Environmental Review Team Report

# Royal Oaks Park II

Middletown, Connecticut

July 1981

# DRAINAGE AREAS

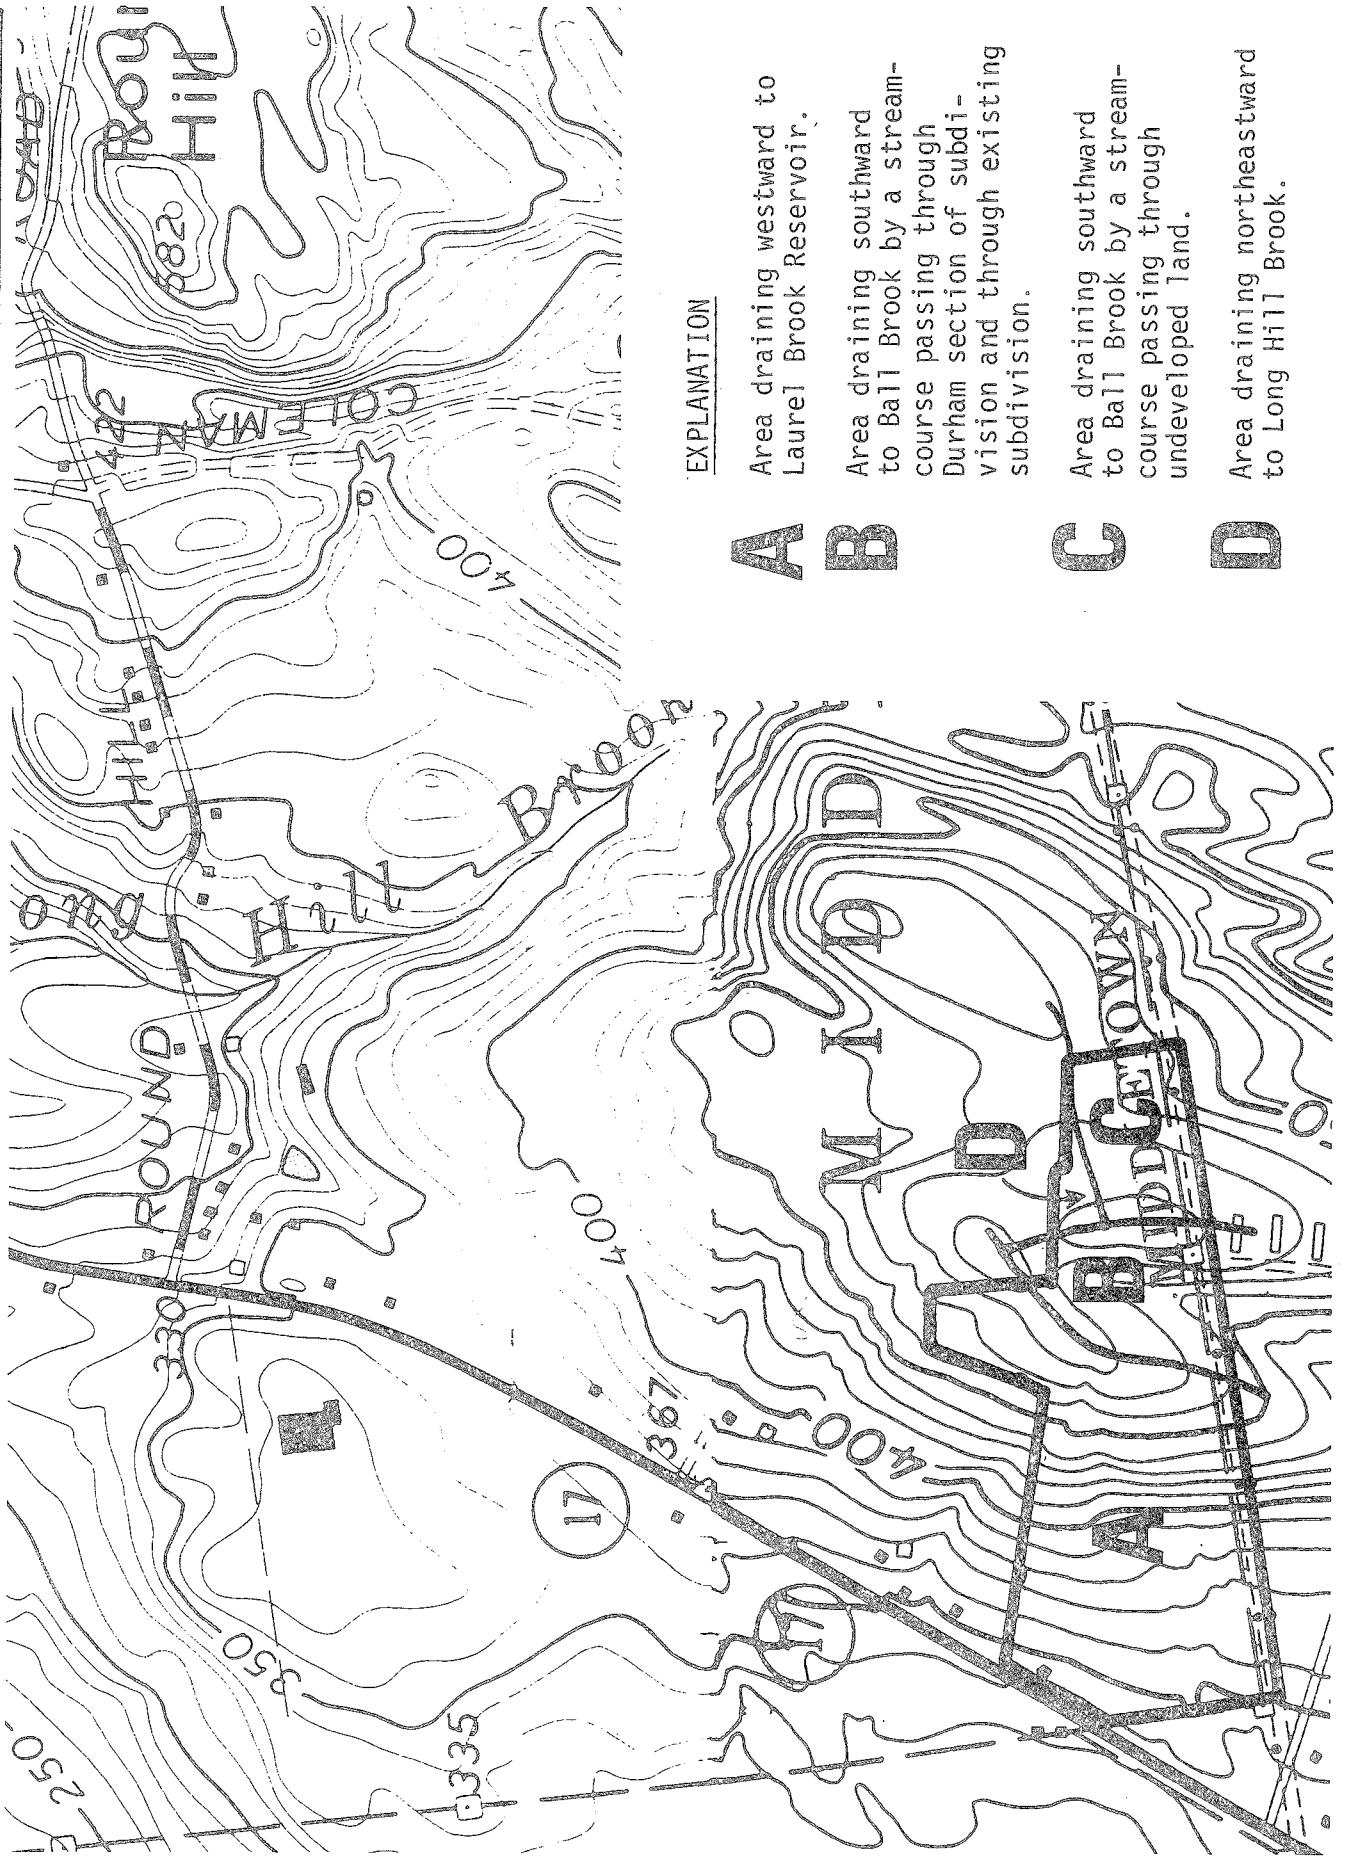
Runoff increases from the central area of the site (Area B on the accompanying illustration) should be of the most concern. The intermittent watercourse that carries drainage from that area passes through the Durham section of the Stollman Property, which the Team reviewed in 1979, and which already has been approved for subdivision. The watercourse then continues southward, flowing by or through lots in an existing subdivision. The Team discussed the expected runoff and peak flow increases on the Durham section of the subdivision in its previous report. Peak flow increases in the stream near one residential lot were expected to range from 14 percent for a 100-year storm to 36 percent for a 2-year storm. The final form of the Durham section of the subdivision may be different from the plan that the

Team reviewed, and the expected runoff increases may no longer be the same as indicated in the earlier report. Nevertheless, the developer should assure that the additional runoff increases that would be generated by the Middletown section of the subdivision will not create or add to flooding or erosion problems in Durham.

# Vegetation

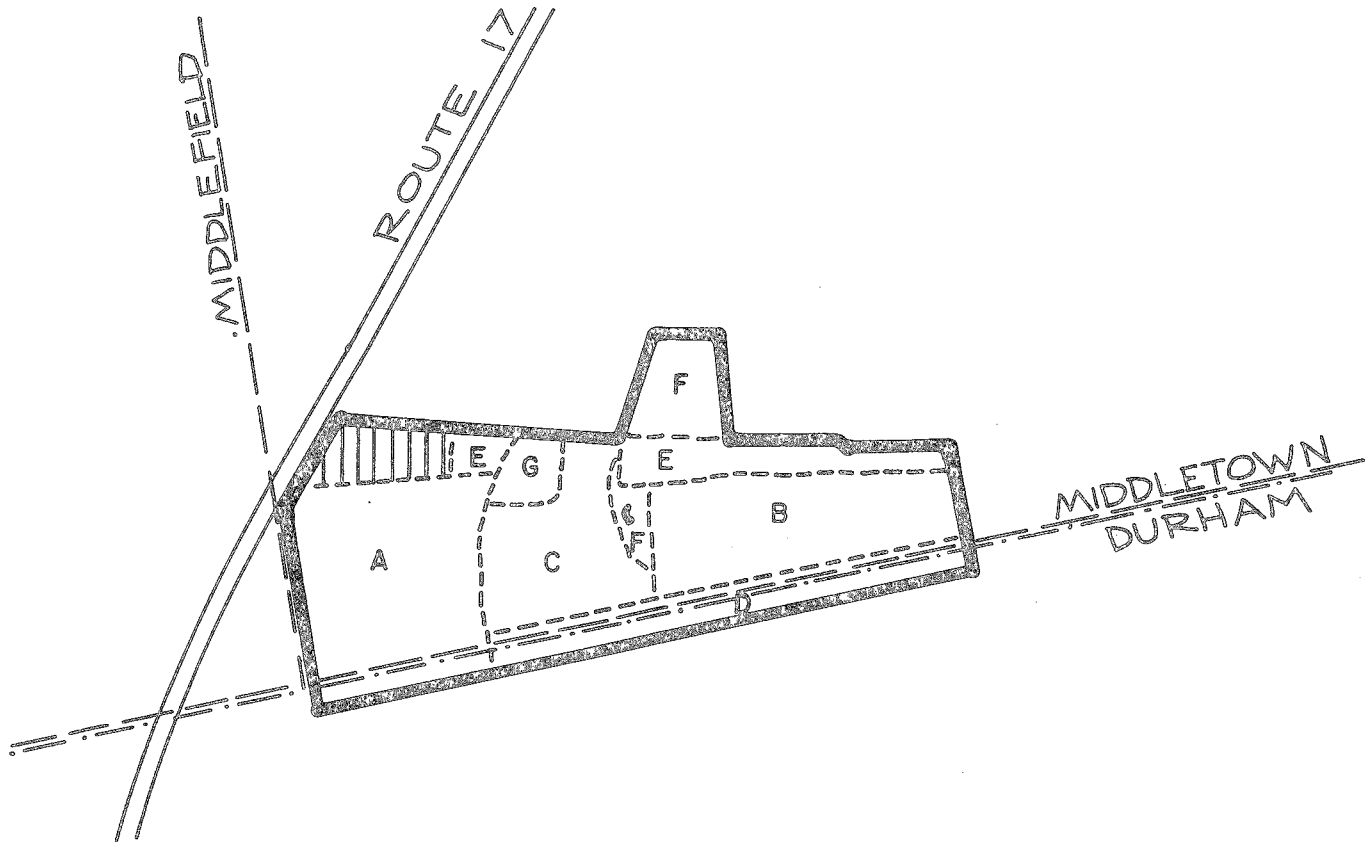
The spruce trees which are present in Vegetation Type G (Plantation) are extremely crowded. Many of these trees do not have enough live crown to sustain enough yearly growth for adequate health. Under these conditions, trees are very susceptible to weather, disease, and insect damage. As a result of their close proximity to each other, they provide support and stability to one another. Large openings made for house lots, septic systems or driveways may increase the potential for further damage by top breakage and windthrow. A light thinning in this stand removing no more than one-third of the total number of trees will help to gradually reduce the crowded condition, improving the health, vigor and stability of the residual trees. Several years after this thinning, the residual trees will be more stable and better able to survive the impact of clearing for development. If the retention of some of these trees is not important enough to hold off development in this area until several years after the proposed thinnings, then the entire stand should be removed all at once to avoid potential hazards.

The trees which are present in both Vegetation Types C and F (Mixed Hardwoods) are also declining in health and vigor due to their crowded condition. Clearing for the development of this property will provide more than adequate space for residual trees to grow. In fact, the intensive clearing may cause residual trees to produce excessive branching caused by abrupt exposure of these trees to direct sunlight.
